Product change information (PCN)

| PCN No.: | AAC170047 | Date: | 23.07.2018 |
| Product: | BC17,8 BC53,6 BC107 | | |

Change to the transparent BC cover

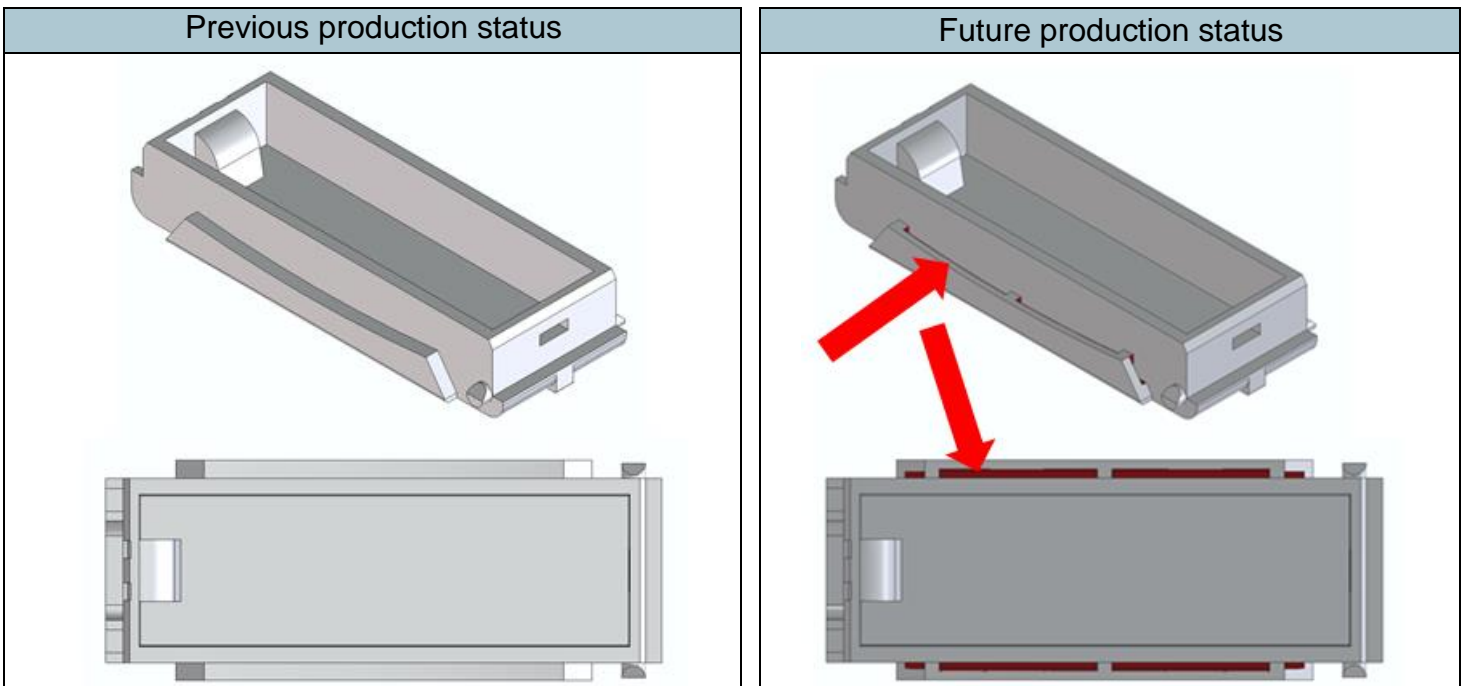
The formation of bubbles and sink marks have been identified in the area of the thicker sections on the transparent cover of the BC housing. As a permanent solution to the identified fault characteristics, the thicker sections have been thinned and redesigned.
